Item Name: Quick Release Heli-Utility-Basket™ Long, HD Lid, Spacepod™/Squirrel Cheek Comp.

DART SERVICE INSTRUCTION

TO AMEND INSTALLATION INSTRUCTIONS D350-607-3 Rev.D,
INSTALLATION INSTRUCTIONS D350-607-4 Rev. C AND
INSTRUCTIONS FOR CONTINUED AIRWORTHINESS ICA-D350-607 REV. 6

A	NEW ISSUE	AJS	14.05.16
REV.	DESCRIPTION	BY	DATE
DESIGN	AJS	DART AEROSPACE LTD HAWKESBURY, ONTARIO, CANADA	
DRAWN	AJS		
CHECKED		DRAWING NO.	REV. A
MFG. APPR.	N/A	DSI 9699	SHEET 1 OF 2
APPROVED		TITLE	SCALE
DE APPR.		LUG REPLACEMENT	NTS
DATE	14.05.16	COPYRIGHT © 2014 BY DART AEROSPACE LTD THIS DOCUMENT IS PRIVATE AND CONFIDENTIAL AND IS SUPPLIED ON THE EXPRESS CONDITION THAT IT IS NOT TO BE USED FOR ANY PURPOSE OR COPIED OR COMMUNICATED TO ANY OTHER PERSON WITHOUT WRITTEN PERMISSION FROM DART AEROSPACE LTD.

FIGURE 1: INSTALLATION OF D4775-041 FWD STRUT

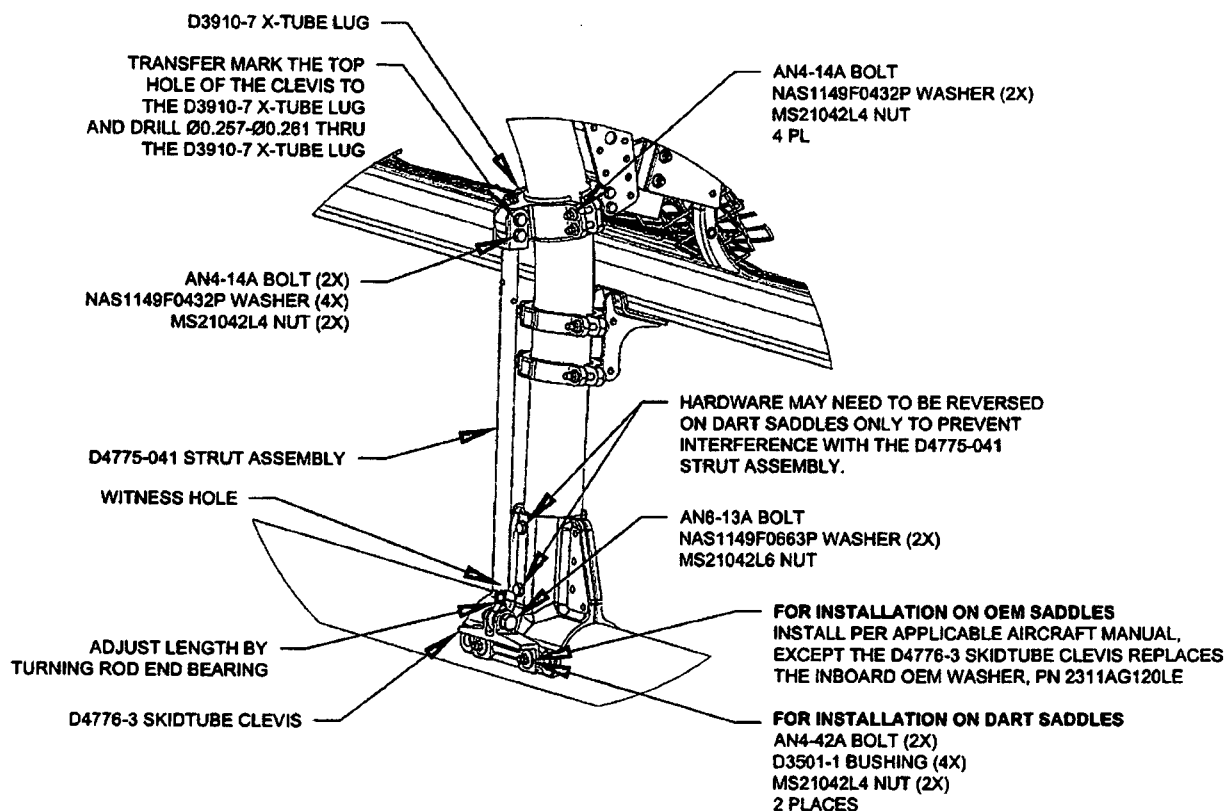
Modify the quantities for D3910-5 and add D3910-7 as follows:

- 3.1 Substitute the Forward Lower D3910-5 X-Tube Lug with the D3910-7 X-Tube Lug as shown in Figure 1.
- 3.2 Install the forward D4775-041 Strut Assembly. Transfer mark from the upper hole on the clevis of the D4775-041 Strut Assembly to the D3910-7 X-tube Lug and drill thru the lug $\varnothing 0.257$ - $\varnothing 0.261$ as shown in Figure 1. Touch up chemical conversion coating per MIL-DTL-5541. Check the witness holes located at the bottom end of the D4775-041 Strut Assemblies to ensure that the thread from the rod end extends past the witness hole.
Torque MS21042L4/-4 nuts to 50-70 in-lbs (5.7-7.9 N-m). Torque MS21042L6/-6 nuts to 160-190 in-lbs (18.1-21.5 N-m).
- 3.3 Complete the installation in accordance with Installation Instructions D350-607-3 Rev. D or D350-607-4 Rev. C.
